Public Works Subcommittee
Follow-up to meeting on 5 February 2013

Item PWSC(2012-13)55

**Public Works Subcommittee
Meeting on 5 February 2013 – Follow-up Action**

工程名稱 PROJECT TITLE
工務計劃項目第 79TI 號
擬議洪水橋第十三區的
公共運輸交匯處
PWP ITEM No. 79TI
PROPOSED PUBLIC
TRANSPORT INTERCHANGE
AT AREA 13, HUNG SHUI KIU

設計師效果圖
ARTIST'S IMPRESSION DRAWING

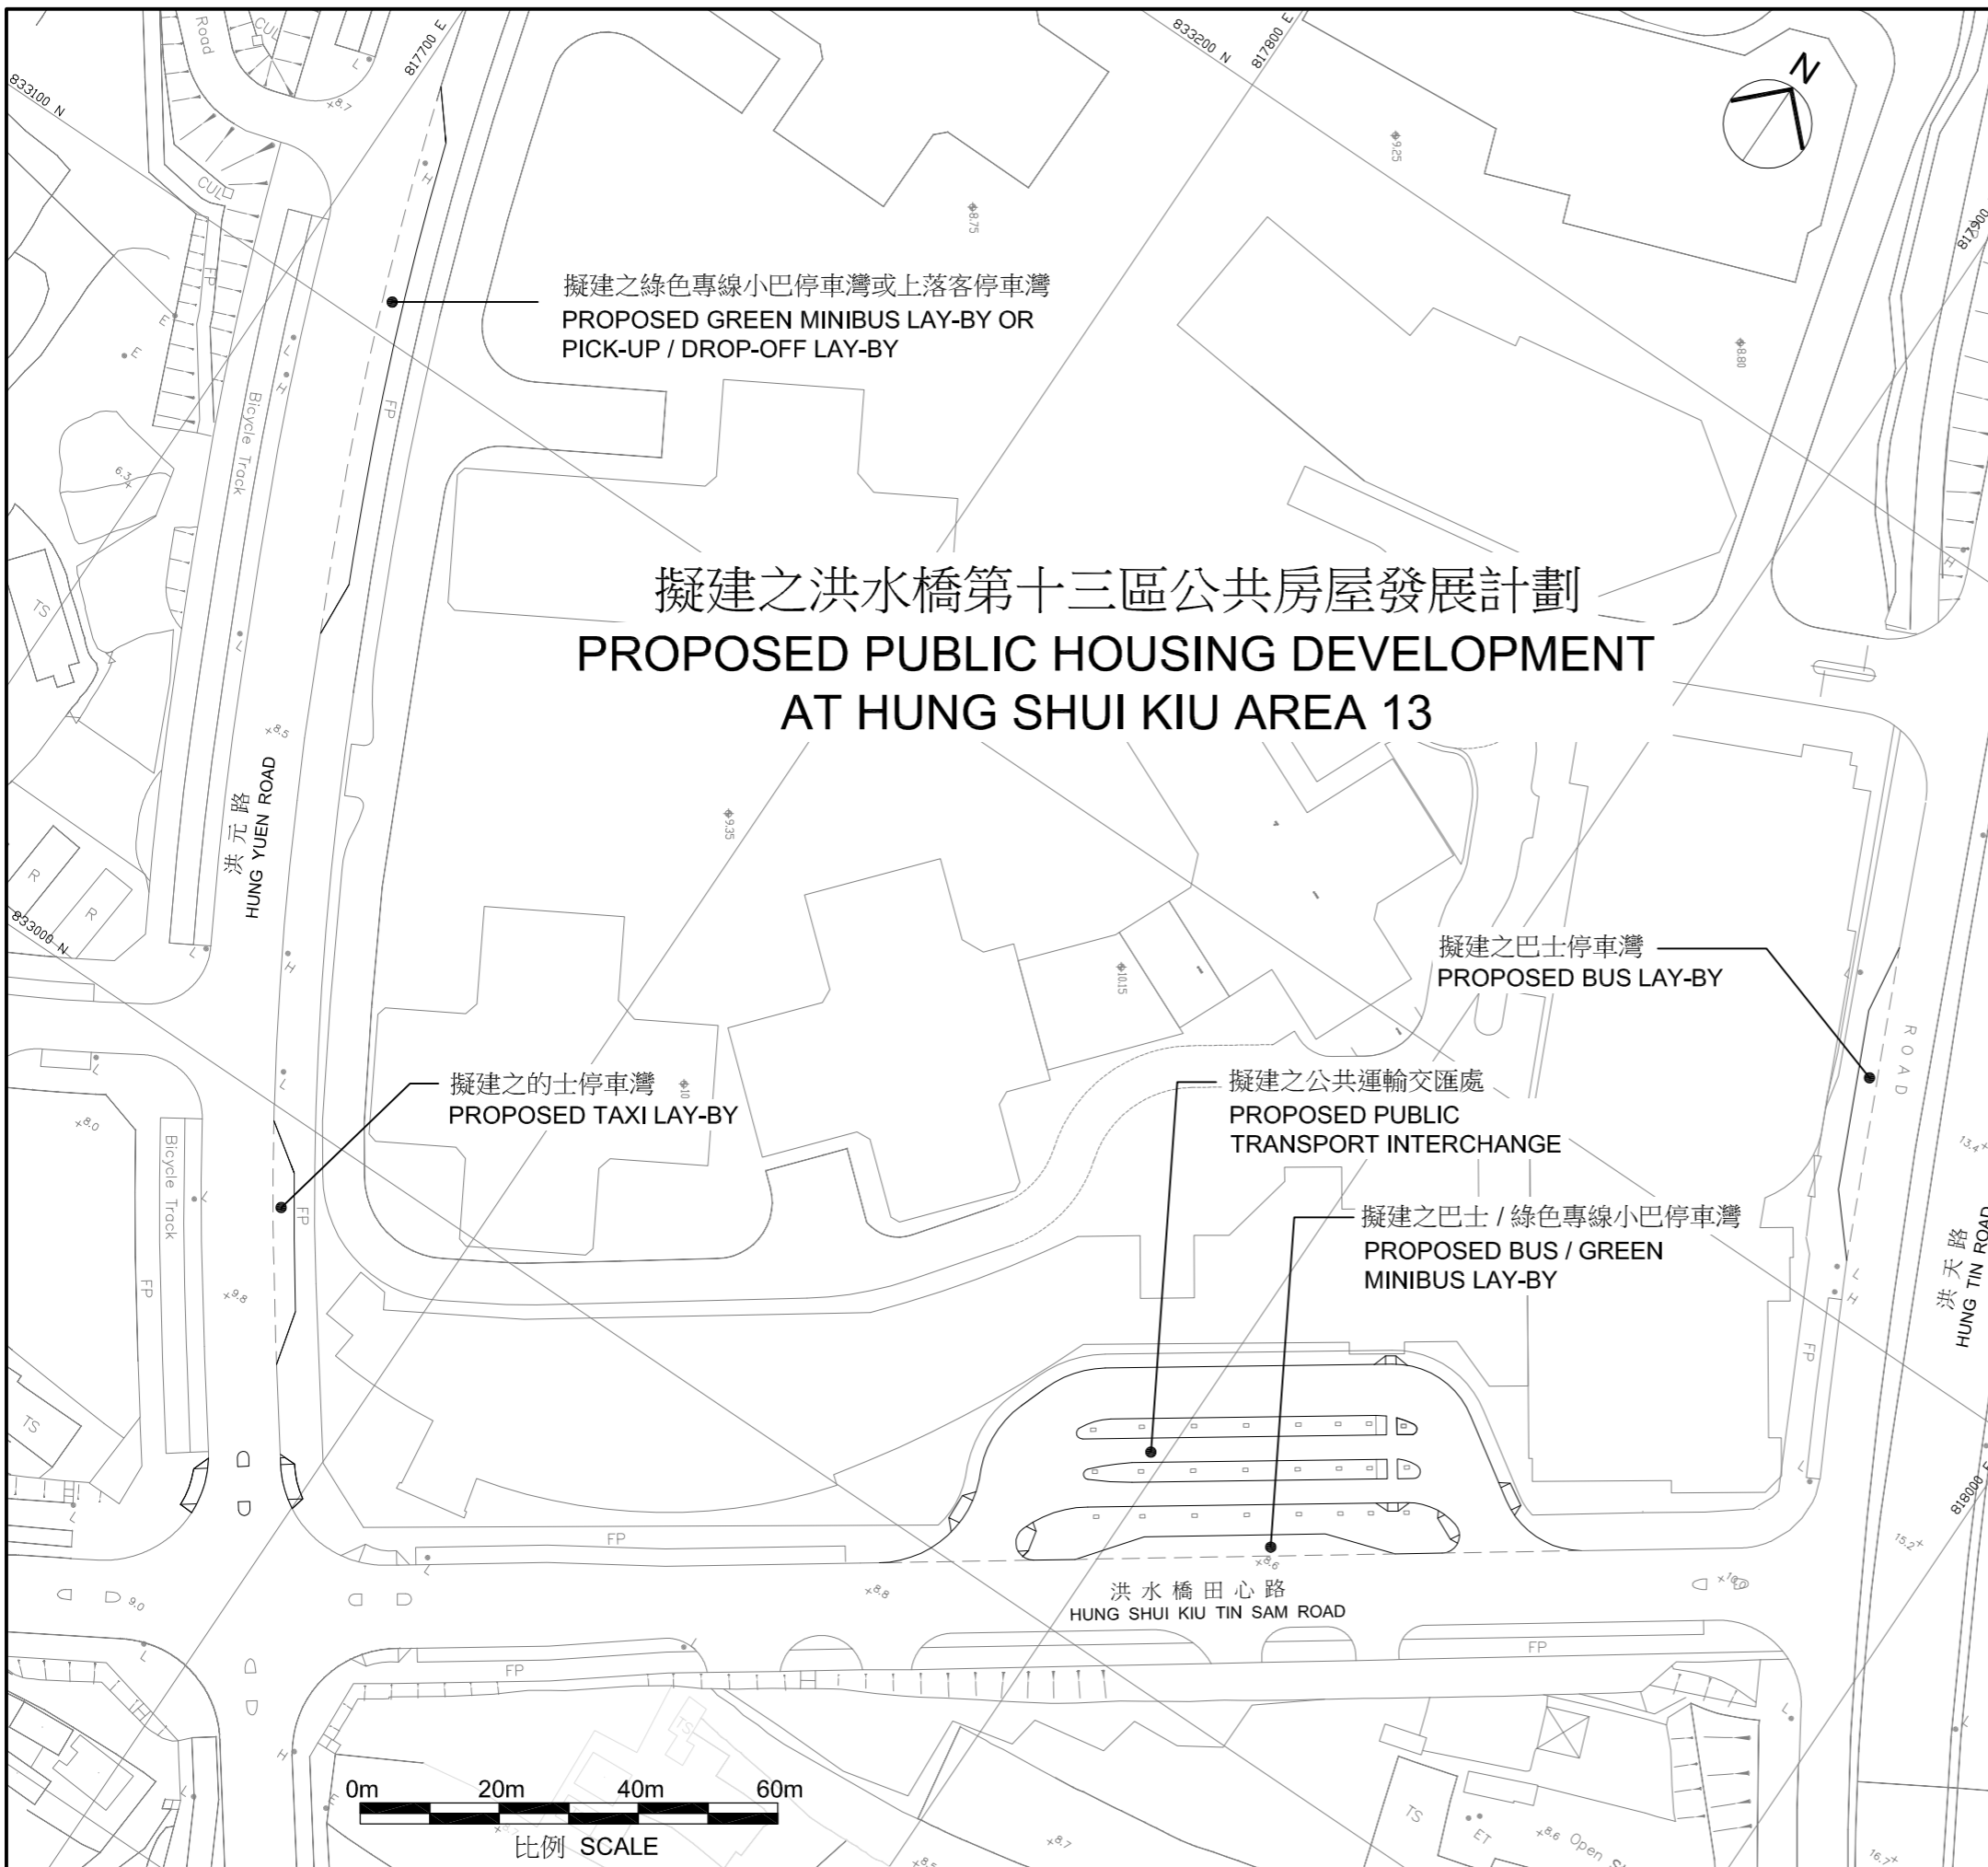
- B) The Administration was requested to review the effectiveness of the design of the PTI in air ventilation and sun shading, and to consider the possibility of providing seats/stand bench for passengers while waiting for buses.**

The Administration would like to highlight that the PTI is open on all four sides, has a high headroom and is also partially open at the roof to encourage natural ventilation. The main purpose of PTI cover is to serve as noise barrier to nearby residents. According to the simulation results of the microclimate study by environmental consultant, the wind environment at PTI area is satisfactory for pedestrian comfort, with wind speed of 2.5m/s and 3.0m/s under summer and annual prevailing wind condition respectively, which is more satisfactory than the generally acceptable wind speed of 1.0m/s under normal circumstances.

In order to provide adequate sun shading and natural lighting for the PTI, the zig-zag roofing structure is to be clad in aluminum roof panels with insulation and translucent panel to reduce heat and radiation. In addition, some stainless steel leaning benches will be provided for passengers queuing at the PTI. An artist's impression of the design elements for the PTI is attached at **Enclosure 2**.

圖則名稱 PLAN TITLE
擬建之公共運輸交匯處
及鄰近停車灣
PROPOSED PUBLIC TRANSPORT
INTERCHANGE AND ADJACENT
LAY-BYS

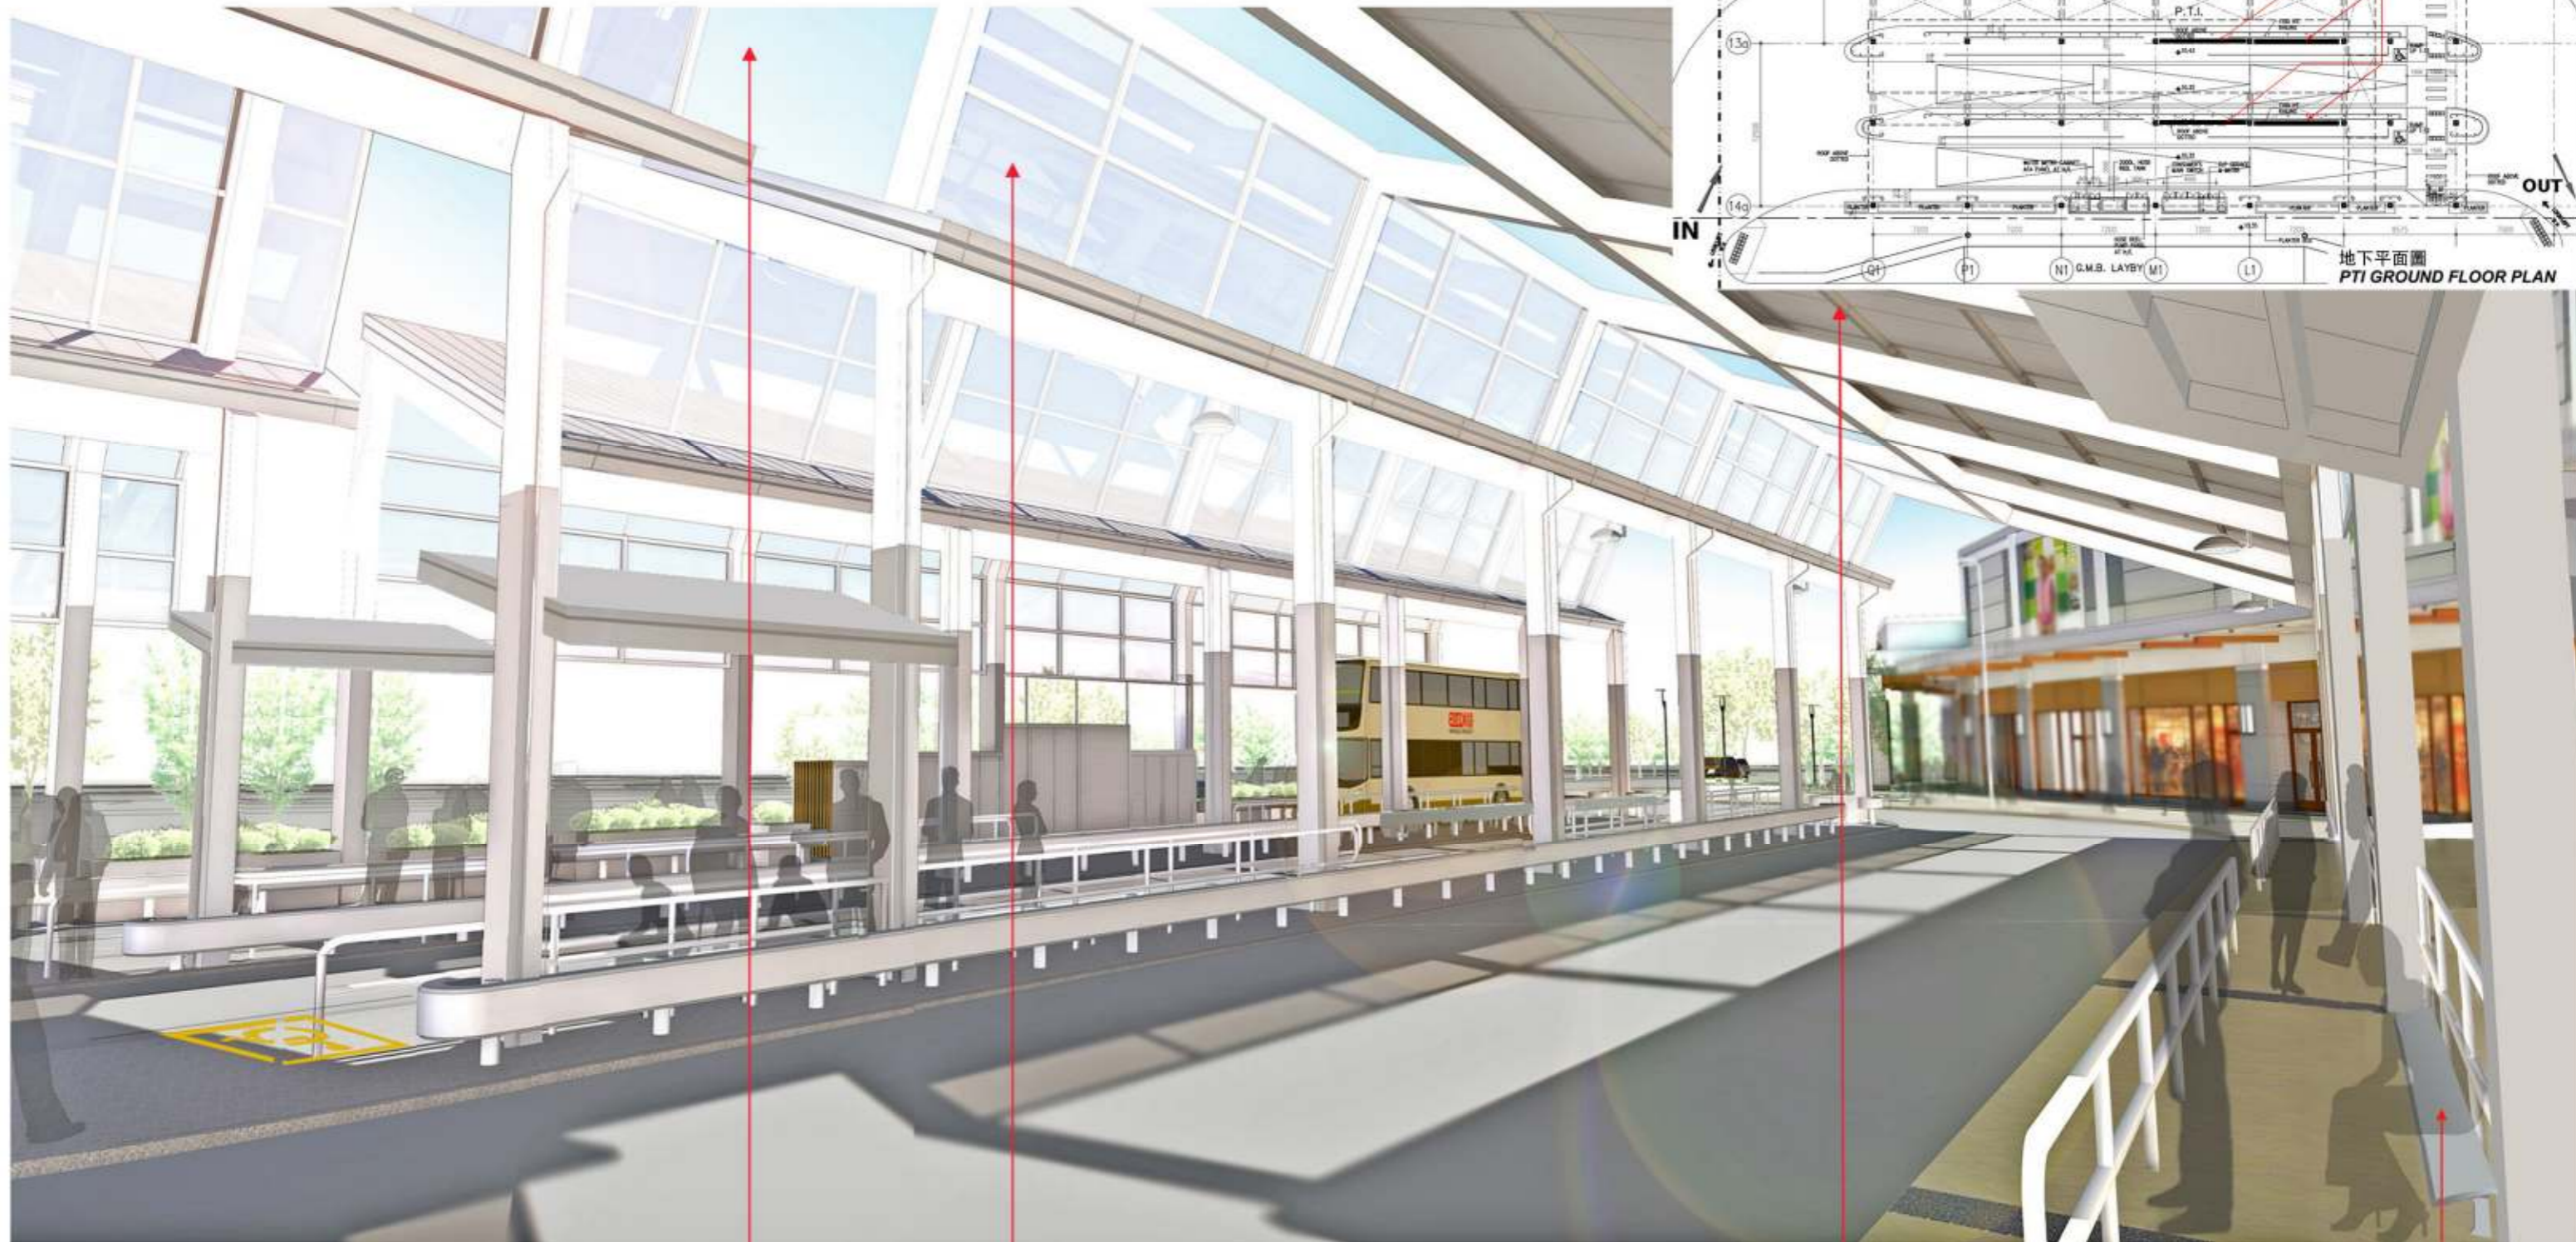
- A) **To maximize the number of bus routes that can terminate at the future Public Transport Interchange (PTI) at Area 13, Hung Shui Kiu and to enhance flexibility for the future operation of the PTI, the Administration agreed to revisit the suitability of providing two double-width bus bays (雙坑) instead of one double-width bus bay and two single-width bus bays (單坑) in the PTI as proposed in the paper.**

In connection with the public housing development at Area 13, the Administration proposes to provide one double-width and two single-width bus bays at the PTI. The design will be able to accommodate four terminating bus routes. On the other hand, lay-bys will be provided on Hung Shui Kiu Tin Sam Road at the southern edge of the PTI, Hung Tin Road northbound and Hung Yuen Road southbound (located at both sides of the development). These additional lay-bys will provide reserved areas as potential terminal points for bus or green minibus services in case of future service enhancement. **Enclosure 1** shows the location of the bus bays and lay-bys.

The Administration has revisited the suitability of providing two double-width bus bays. According to current design standard, a double-width bus bay of 40 metres in length can only accommodate the operation of two bus routes (with bus of 12 metres in length) at the same time since a clearance of 13 metres between two bus routes share-using the same bus bay should be provided to enable the bus at the rear to pull out and overtake the bus ahead safely when leaving the bus bay. Hence, if the design of the PTI is revised to two double-width bus bays of 40 metres in length, it can only accommodate at most four terminating bus routes, same as the design proposed by the Administration.

With the provision of single-width bus bay, a clearer and more orderly queuing arrangement can be provided for passengers. This arrangement may also facilitate bus company outdoor staff to better manage the order of passengers. In addition, the Administration's proposed PTI can allow more space for brief layover of buses at the PTI. A 40-metre single-width bus bay is sufficient for three 12 metres long buses to layover at the same time. When the first bus is engaged in picking up passengers, two other buses covering the same route may stay at the remaining space for brief layover purpose, without causing any obstruction to the normal bus operations. No such space can be provided for brief layover of buses if two double-width bays are provided at the PTI. In light of the above, the

PTI design proposed by the Administration is considered more suitable than a design using two double-width bus bays.
